Objecting Submission to State Significant Development

Project Number SSD-10315, Bowmans Creek Wind Farm

10 May 2021

9.8.83 Viewpoint Q17-3 Visibility rose

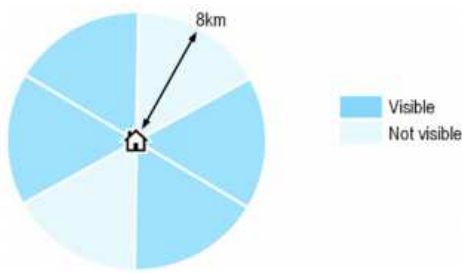
10. Table 9-28 at page 180 of the 02 APP H Visual Assessment Report states that '*Wind turbines within four 60-degree sectors are not considered to dominate the available viewshed.*' However, when considering the included diagram of the visibility from the rural dwelling (Image 9.8.83 at page 179, reproduced below), it is evident that at least 60% of the dwelling's visibility will be impacted by the turbines, specifically 26 turbines between the blue line and black line. The project does not offer any mitigation options, instead stating that '*Tree cover and a gently undulating landform to the south east of dwelling Q17-1 **may provide some degree** of filtering views toward **some** wind turbines*' (emphasis added). This indicates that the existing tree cover and landform is unlikely to provide any realistic filtering of views, and if it does so, it will not filter all turbines from view. It is not clear how this fulfils the stated objective of 'manage impacts as far as practicable', when no practical management options have been considered.
